Process Change Notification

PCN #: 33221

All devices in SOIC and PDIP packages.

Appendix A
PCN33221 – New PDIP and SOIC Top Marking Codes (after date code 0927)

SOIC — Top Marking Description

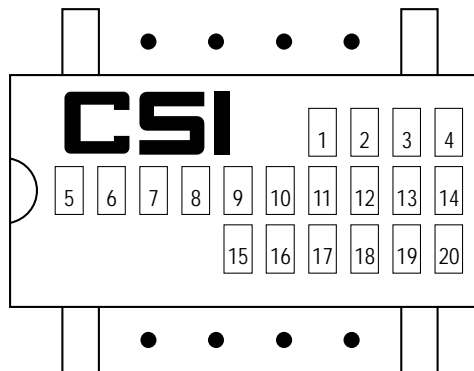
The device marking will be modified to show all information on the top.
The bottom mark is to be eliminated.

The position of some marking codes will be altered.
A description of the top mark locations is shown on Appendix A (page 2).

All devices in an SOIC and PDIP package will have marking on the topside only
per Appendix A.

Top Mark Legend (Position)

1 2 3 4 Voltage/resistance value (if applicable),
assembly location, lead finish, product revisor

5 6 7 8 9 10 11 12 13 14 Device name

15 16 17 18 19 20 Date code and production lot code
